| TOLERANCES (UNLESS OTHERWISE NOTED) | WESTERBEKE CORPORATION AVON MA. 02322 | | |
|---|---|---|---|
| INCHES / MILLIMETERS | TITLE: WIRING DIAGRAM, 15.0 BTDA, 20, 25, 32 BED W/ELECTRONIC GOVERNING | | |
| DIMENSIONS INCHES / MILLIMETERS | SCALE: NONE | SIZE: E | DRAWING NUMBER: 39422 |

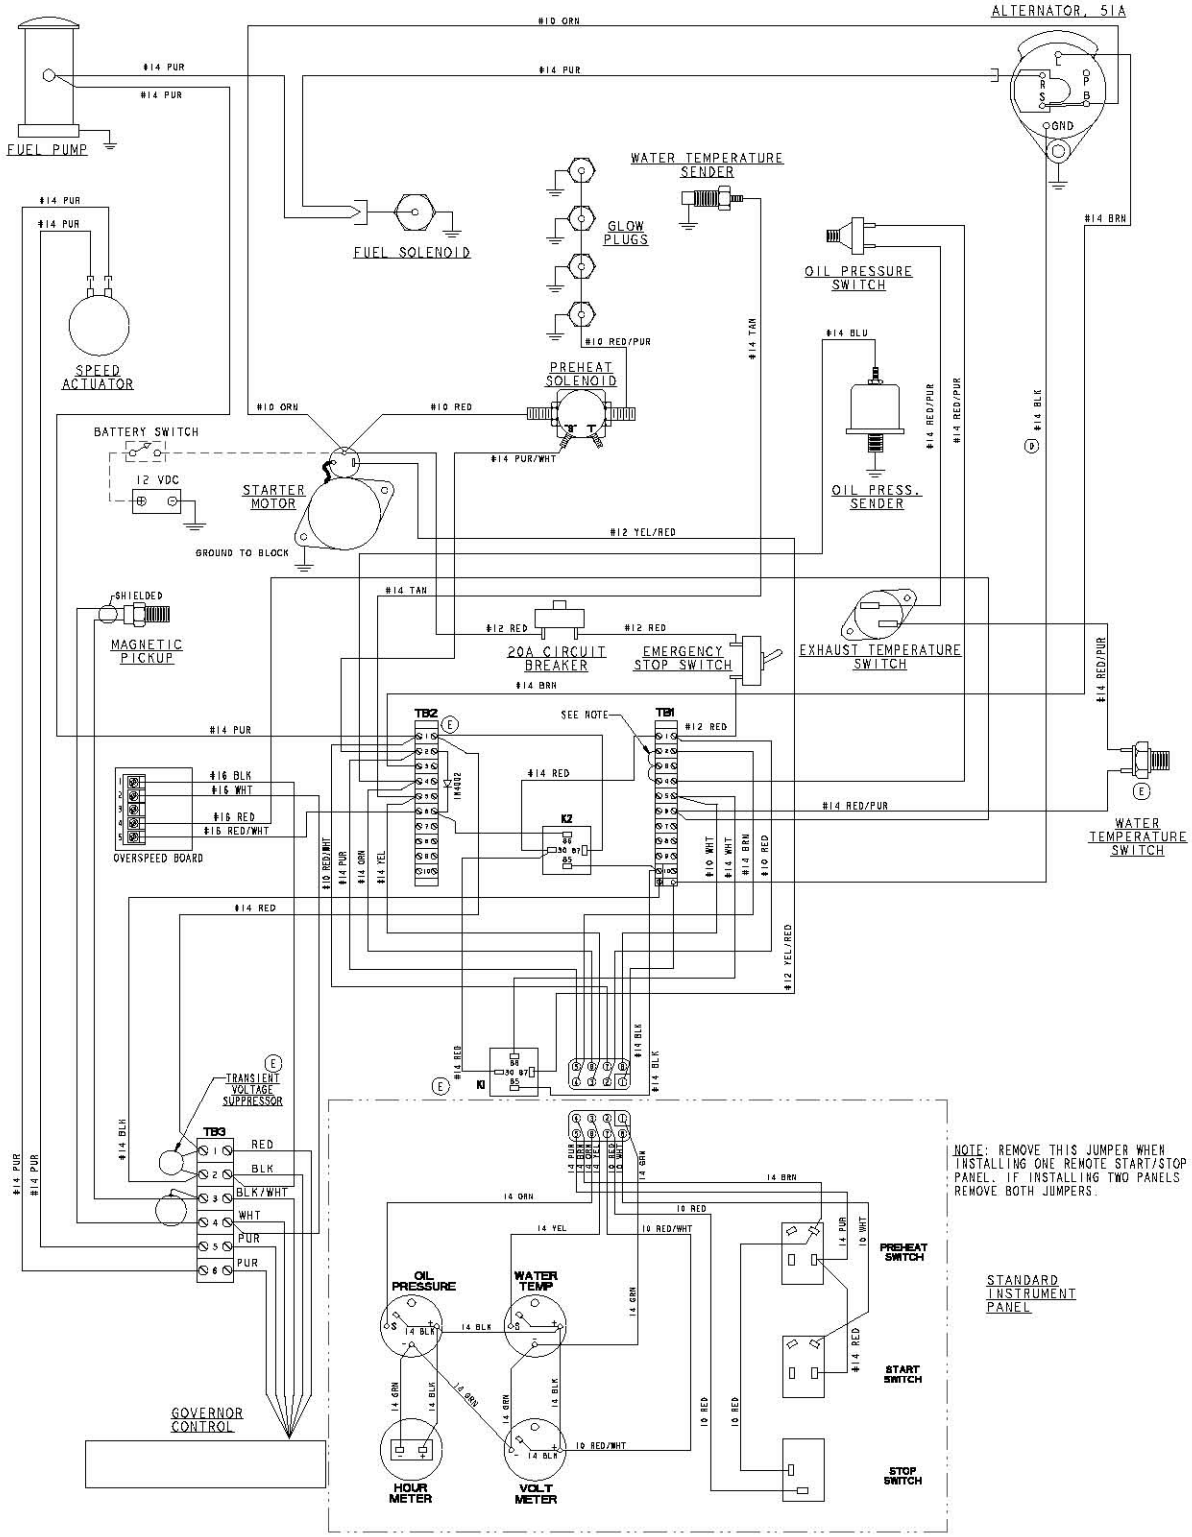
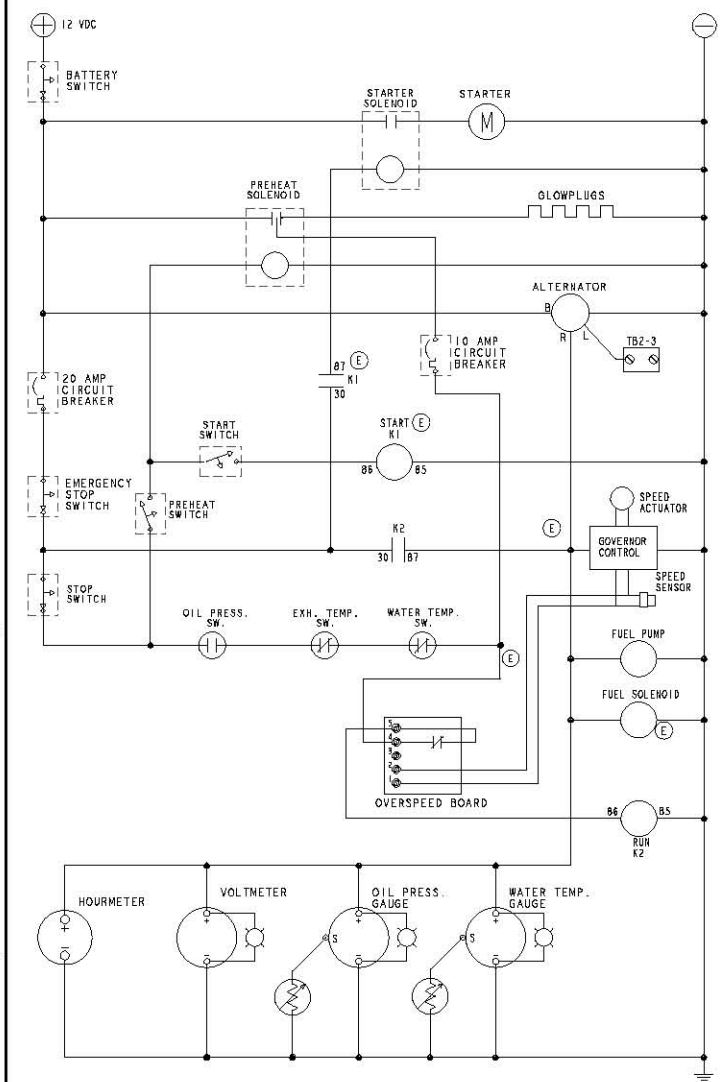
| ECO NO. | DATE | REV. | REVISION RECORD | AUTH. | DR.BY |
|---|---|---|---|---|---|
| 2083 | 1/27/93 | A | ADDED RELAY TO THE CONTROL BOX; WIRING RAN FROM TB1-3 TO EXHAUST TEMP. SWITCH TO O.P. SWITCH TO WATER TEMP. SWITCH. NOW FROM TB1-3 TO O.P. SWITCH TO EXHAUST TEMP. SWITCH TO WATER TEMP. SWITCH | | WRM |
| 2193 | 6/14/93 | B | TERMINAL BLOCKS TB1 AND TB2 WERE 5 POSITION BLOCKS, NOW 10 POSITION BLOCKS | | WRM |
| 2716 | 4/11/95 | C | O.P. SW. WAS CLOSED, EX. TEMP SW. WAS OPEN | | MKM |
| 3081 | 10/9/96 | D | CHANGE ALT. GROUND WIRE FROM GRN TO BLK | | BRN |
| 4664 | 8/3/00 | E | ADDED RELAY K2, REMOVE 10A C.B.; ADDED CORRECTION TO GOVERNOR FROM FUEL PUMP. ADDED TRANSIENT SUPPRESSOR TO CIRCUIT. | | TSM |
| 5536 | 4-23-2003 | F | ADDED OVERSPEED BOARD | | GA |
